APPLICATION NO.	FILING DATE	FIRST NAMED INVENTOR	ATTORNEY DOCKET NO.	CONFIRMATION NO.
10/587,779	07/28/2006	Gordon Thelwell	5897-000029/US/NP	9918
27572                      7590                      05/09/2011 HARNESS, DICKEY & PIERCE, P.L.C. P.O. BOX 828 BLOOMFIELD HILLS, MI 48303				
EXAMINER				
RODDEN, JOSHUA E				
ART UNIT		PAPER NUMBER		
3637				
MAIL DATE		DELIVERY MODE		
05/09/2011		PAPER

### Office Action Summary

### **DETAILED ACTION**

**Annotated Figure 2**

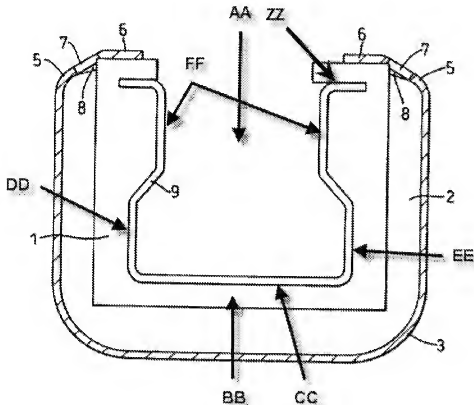
Regarding **Claims 61-64, 80-83, 86 and 87**, Ian teaches; **Claim 61** - a column protecting device (3) for protection of an upright column (9 – wherein it should be understood that the “upright column” is only recited in claim 61 and its dependent claims in terms of the intended use of the “column protector”, and thus the prior art “column protector” of Ian only needs to be capable of performing the intended use, and thus Ian is not required to teach all of the specifics of the “upright column”; Therefore, the “upright column” in this rejection is only detailed in order to detail the functionality of the “column protector” of Ian

in regards to the intended use language of the claims, Also See "Response to Arguments Section" Below) of a racking system, (Figure 3); wherein the column (9) has a channel shaped cross section (AA) having a substantially rectangular front portion (BB) consisting of a front member (CC), first and second outer side members (DD and EE), first and second inner side members (FF), first and second connecting members connecting the first and second outer side members (DD and EE) to the first and second inner side members (FF), respectively, (Annotated Figure 2 Below); a first outer lip member (one of two outer lips being shown as (ZZ)) extending outwardly from an outer edge of the first inner side member (FF) and extending in a plane substantially parallel to the front member (CC), and a second outer lip member (ZZ) extending outwardly from an outer edge of the second inner side member (FF) and extending in a plane substantially parallel to the front member (CC), (Annotated Figure 2 Below); the column protector device (3) being arranged to clip onto the upright column (9), (Figure 2 and Page 4, Lines 10-14); the protector device further comprises a rigid part cylindrical "C" shaped cross section outer shell (3), and an inner liner (1 and 2) shaped to fit within the outer shell (3), (Figure 2 and Page 3, Lines 3-8 of the specification); wherein the outer shell (3) is capable of fitting around the upright column (9) so that the outer shell (3) retains to the column (9) without further fixtures, (Figure 2 and Page 4, Lines 10-14); the outer shell (3) also surrounds the front member (CC), the first and second outer side members (DD and EE), and the first and second connecting members, such that the outer shell (3) is coupled to and received by the first and second inner side members

(FF) of the upright column (9), (Annotated Figure 2 Below, wherein it should be understood that the outer shell (3) would be functionally "capable of" having the end portions of the outer shelf (3) being "received" by the inner side members (FF) if the outer shell (3) was placed over a different size or shaped column (9) such as a column (9) having portions (ZZ) having extensions which wrap around the end portions (6) of the outer shell (3), Also See "Response to Arguments Section" Below); the inner liner (1 and 2) being retained between the outer shell (3) and the column (9), (Figure 3); the inner liner (1 and 2) comprises a solid substantially part cylindrical member having a substantially part cylindrical outer surface (the outer corners of (2) are rounded and the inner liner is therefore part cylindrical), the inner liner (1 and 2) also having a substantially "U" shaped channel (the inner surface of the liner (1) touching the upright column (9)) formed on an opposite side of said inner liner to said substantially part cylindrical outer surface and in which, in use, said channel provides for a flush interface between the inner liner (1 and 2) and the upright column (9), (as seen in Figure 2); **Claim 62** – the outer shell (3) being capable of partially surrounding the first and second inner side members (FF – wherein it should be understood that the outer shell (3) would be functionally "capable of" only partially surrounding the inner side members (FF) if the outer shell (3) was placed over a different size or shaped column (9) such as a column (9) having portions (ZZ) having extensions which wrap around the end portions (6) of the outer shell (3), See "Response to Arguments Section" Below) so that the exposed upright edges (the end edges near item (6) in Annotated Figure 2) of the outer shell (3) lay adjacent to the

sides of the column (9) at a position where the column (9) is relatively narrower, (Annotated Figure 2 Below); **Claim 63** – wherein, in use, the column (9) resides partially within a channel formed by the outer shell (3), (Figure 2); **Claim 64** – wherein said outer shell (3) comprises an elongate member having a substantially “C” shaped cross section, (Figure 2); **Claim 80** – wherein said inner liner (1 and 2) is capable of, after receiving an impact, the inner liner (1 and 2) promotes the repositioning of the whole device to an original shape before the impact occurred, (Figure 2 and Page 4, Lines 3-8); **Claim 81** - the outer shell (3) surrounding the front member (CC) and being capable of partially surrounding the first and second inner side members (FF – wherein it should be understood that the outer shell (3) would be functionally “capable of” only partially surrounding the inner side members (FF) if the outer shell (3) was placed over a different size or shaped column (9) such as a column (9) having portions (ZZ) which wrap around the end portions (6) of the outer shell (3), See “Response to Arguments Section” Below), and also surrounding the inner liner (1 and 2), which rests between a substantially part cylindrical inner surface of the outer shell (3) and an outer face of the front member (CC), an outer face of the first outer side member (DD) and second outer side member (EE), (Annotated Figure 2 Below); **Claim 82** - the inner liner and outer shell being slideable with respect to each other along a central axis of the outer shell, (Page 1, Lines 24-28); **Claim 83** - the outer liner and an inner liner being bonded together, (Page 2, Lines 1-5); **Claim 86** - the outer shell and the inner liner composed of polycarbonate and foam (Page 2, Line 8 and Page 2, Lines 6-7); both materials having greater ductility,

Annotated Figure 2, Version #2 (Jan)

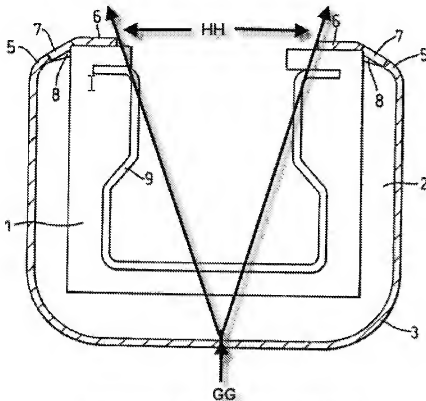
Regarding **Claim 65, lan as modified by Homolka et al.** teaches the column protector as described above (See Rejection of Claim 61 Above), in addition to **lan** teaching the outer shell (3) comprising a tubular substantially cylindrical member (3), (Figure 3); wherein the tube has a pair of substantially parallel opposing edges (the end edges near item (6) in Annotated Figure 2, Version #2 Below) on either side of a gap, (Figure 2). **lan as modified by Homolka et al.** does not teach the cylindrical member extending over an angle in the range of 260 to 280 degrees, but **lan** does teach a range (HH) about a longitudinal centre line (GG) of the outer shell (3) which is very similar to the claimed range, (Annotated Figure 2, Version #2 Below). Therefore, the examiner points to case law *In Gardner v. TEC Systems, Inc.*, 725 F.2d 1338, 220 USPQ 777 (Fed. Cir. 1984), *cert. denied*, 469 U.S. 830, 225 USPQ 232 (1984). The court found that if the only difference between the prior art device and the claims was a recitation of relative dimensions and a device having those claimed

dimensions would not perform differently than the prior art device, the claimed device was not patentably distinct from the prior art device (See MPEP 2144). It would have been obvious to one of ordinary skill in the art to modify the prior art device of **Ian as modified by Homolka et al.** to have the cylindrical member extending over an angle in the range of 260 to 280 degrees for the purpose of user design as it would not cause the device to perform differently.
